Optional Cable Resistance Measurement (CRM) - Part 2

GITESH BHAGWAT, ANDY GARDNER, HEATH STEWART
SANTA BARBARA DESIGN CENTER

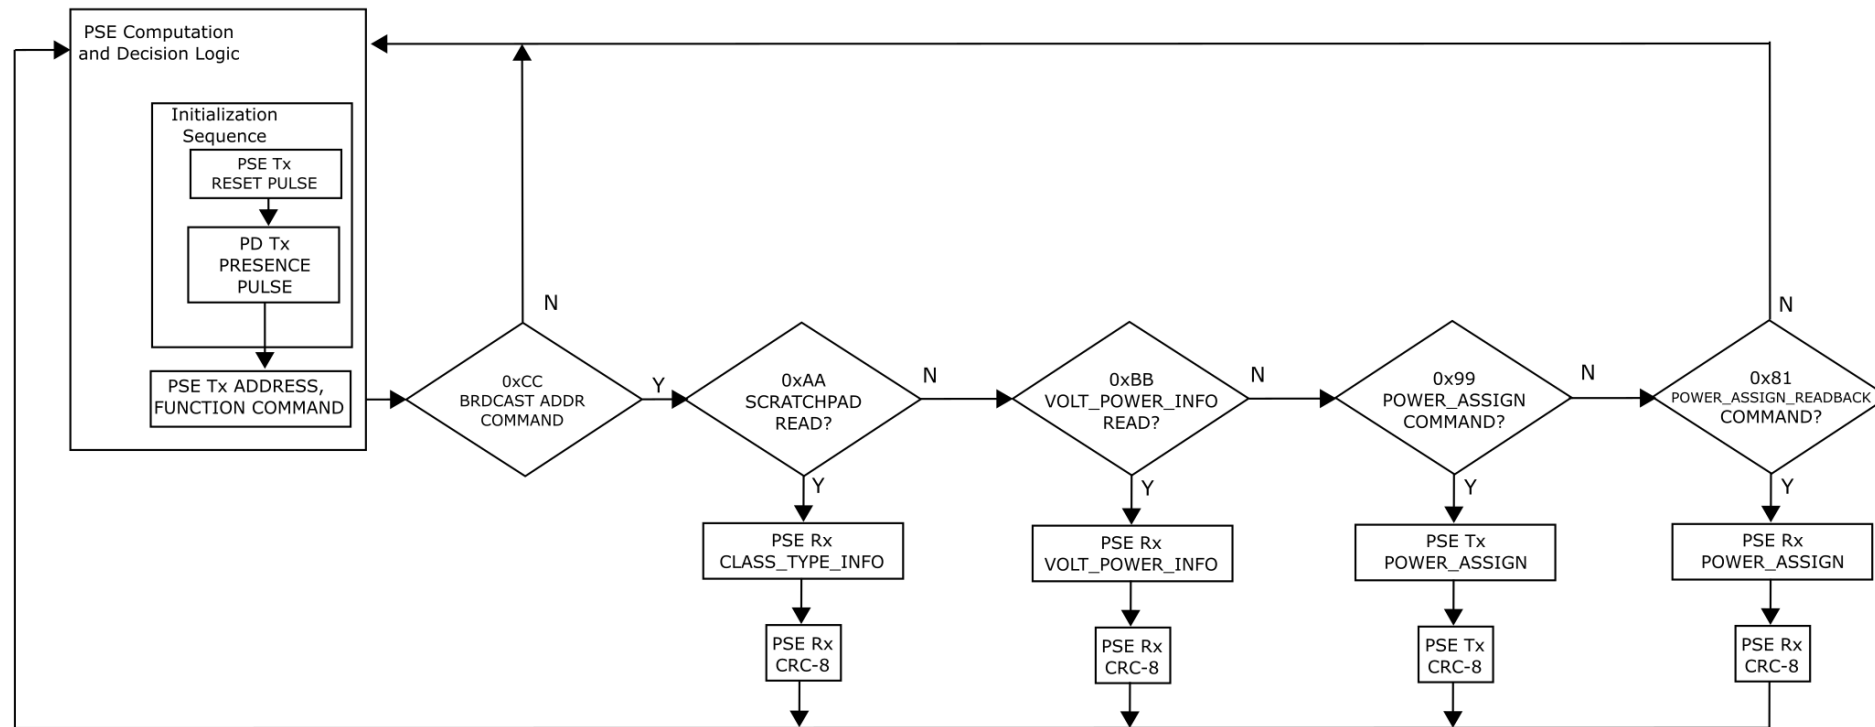
- Add SCCP Command
 - 0x81 : POWER_ASSIGN_READBACK
- Replace Figure 104-13 with the figure shown on this slide
